N62661.AR.002601
NS NEWPORT
5090.3a

U S NAVY RESPONSES TO U S EPA COMMENTS TO DRAFT FINAL PHASE 2 REMEDIAL
INVESTIGATION AND BASELINE ECOLOGICAL RISK ASSESSMENT SITE 17 GOULD
ISLAND NS NEWPORT RI
8/1/2011
U S NAVY

NAVY RESPONSES TO US ENVIRONMENTAL PROTECTION AGENCY (EPA) COMMENTS (DATED SEPTEMBER 20, 2011) DRAFT FINAL PHASE 2 REMEDIAL INVESTIGATION, AND BASELINE ECOLOGICAL RISK ASSESSMENT – AUGUST 2011, SITE 17, GOULD ISLAND NAVSTA NEWPORT, NEWPORT RHODE ISLAND

FIGURE NUMBER
2-4

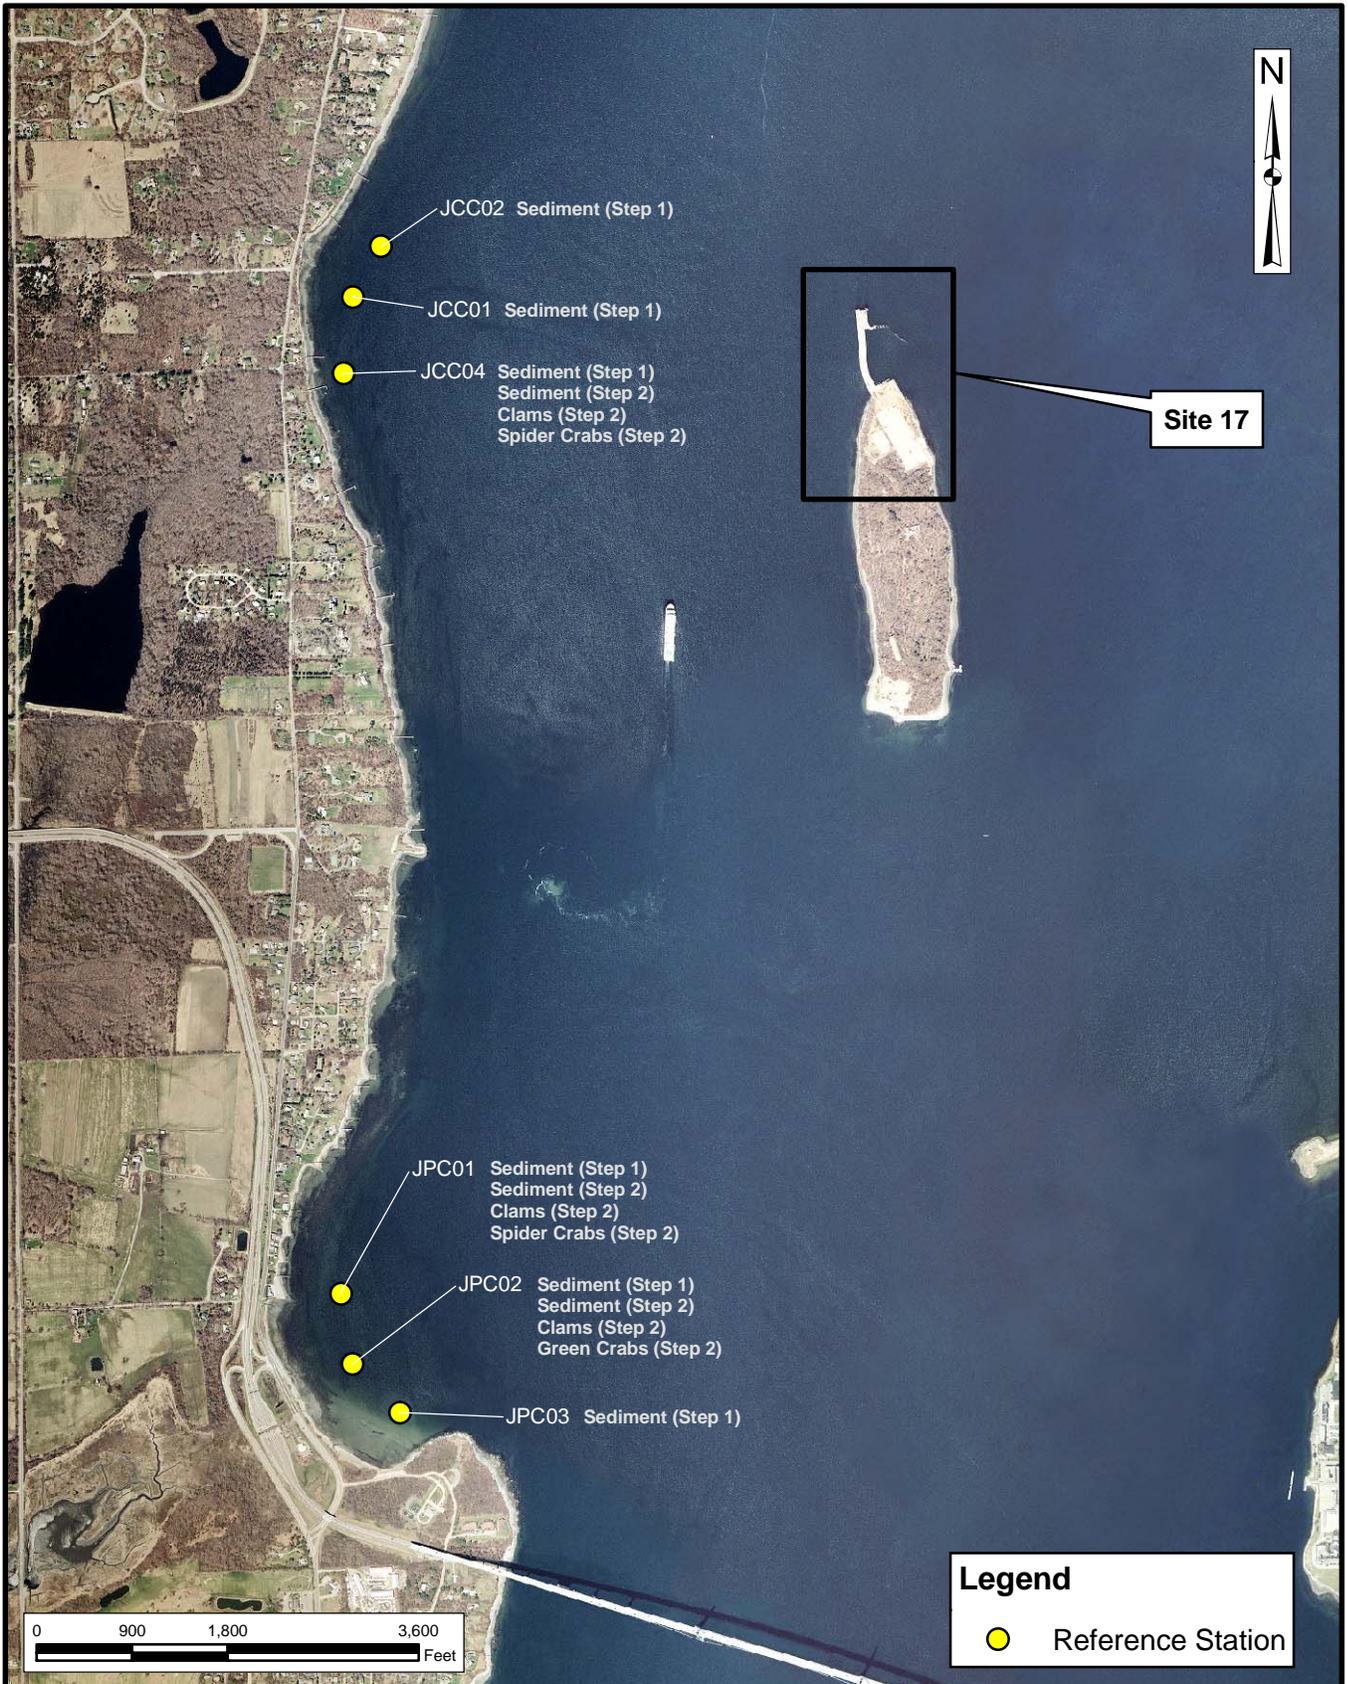
Comment 11, p. 7-13: Please discuss whether biota contamination is an issue at the Site. It is unclear where the reference locations for clam/mussel and crab collection are and how background is defined for shellfish, which can migrate. Please also refer to tables 4-23 through 4-31 and Figure 2-2 for biota sampling locations.

Comment 13, Tables 4-23 to 4-31 & Figure 2-2: It is not clear from these tables where the background clam/mussel and crab samples are located. Please provide. From the tables and the text, it is also unclear how many background sample locations are included. Since contaminants found in shellfish are proposed for exclusion because of high background concentrations, further detail and discussion need to be provided.

Response: The reference locations are presented on Figure 2-4. As presented on Tables 2-6, 4-30 and 4-31, there were three reference samples, and clams and crabs were collected at all three. Figure 2-4 is revised and attached to this response summary to show where these reference samples were located.

Response: The reference locations are presented on Figure 2-4 (revised and attached). Locations and number of reference samples are also presented on Table 2-6. As presented on Tables 2-6, 4-30 and 4-31, there were three reference samples for clams and three for crabs. The specific reference sample locations are listed in the last three rows on Table 2-6, and the second row on Tables 4-30 (clams) and 4-31 (crabs) (JPC-01, JPC-02, and JCC-04). Tables 4-23 through 4-29 will be footnoted to provide reference within the document to the tables presenting the reference data and to the revised Figure 2-4 showing locations.
